UNITED STATES PATENT AND TRADEMARK OFFICE

Office Action Summary

10/674,092

Paper No:11302005
Application No: 10/674092
Filing Date: September 29,2003

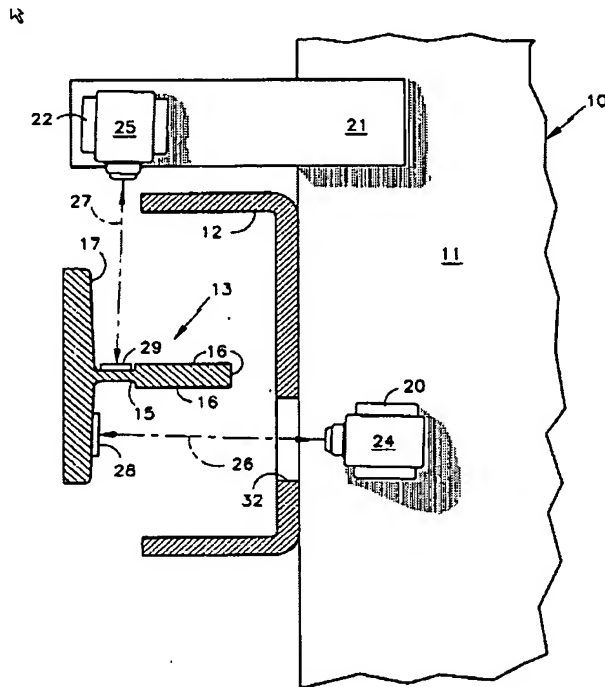
7. Claim 2 is rejected under 35 U.S.C. 102(b) as being anticipated by Dobler et al (6128116).

Dobler et al teaches an elevator hoistway position sensor.

Rail 17. Target 29 in pocket 15. Sensor 25 on car 11 determines limits (zones).

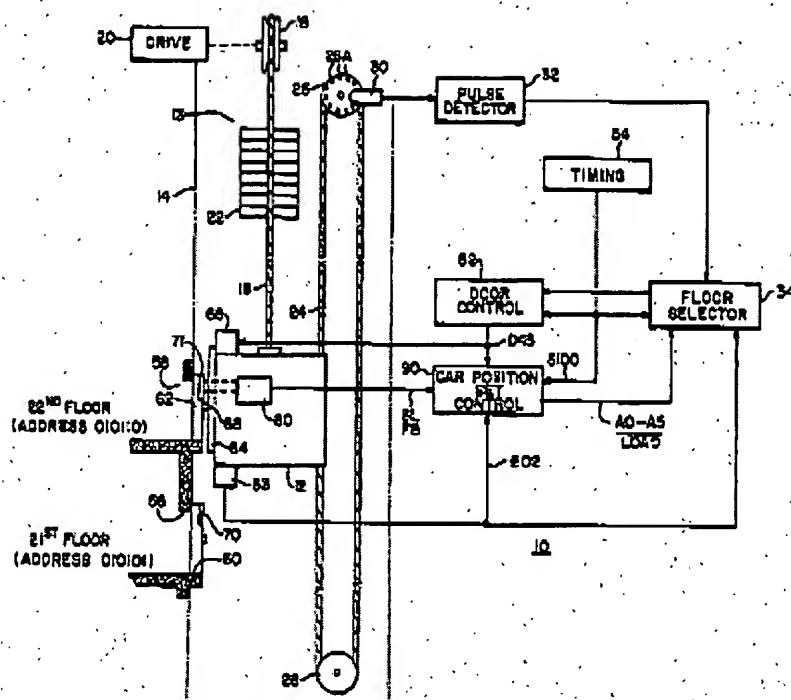
Zolnerovich et al teaches in figures 1-4, an elevator control system.

Pulse reader 32 and readers 80,83 determine the speed etc. and landing/door zones for the control of the elevator car 12. Targets 70,71 containing coded transmitters specify the landing/door zones and floor location.

Zolnerovich et al does not illustrate the targets 70,71 in a pocket on the guide rail.

Dobler et al teaches that it is advantageous to place the targets in a pocket in the guide rail and utilize a reader for the targets due to high maintenance and noise of conventional switches/rollers. Thus, to utilize a reader for position/speed control of an elevator wherein the targets are place on on in pockets on the rail would have been an obvious engineering design choice to one of ordinary skill in the art to reduce noise and lower maintenance for the elevator.
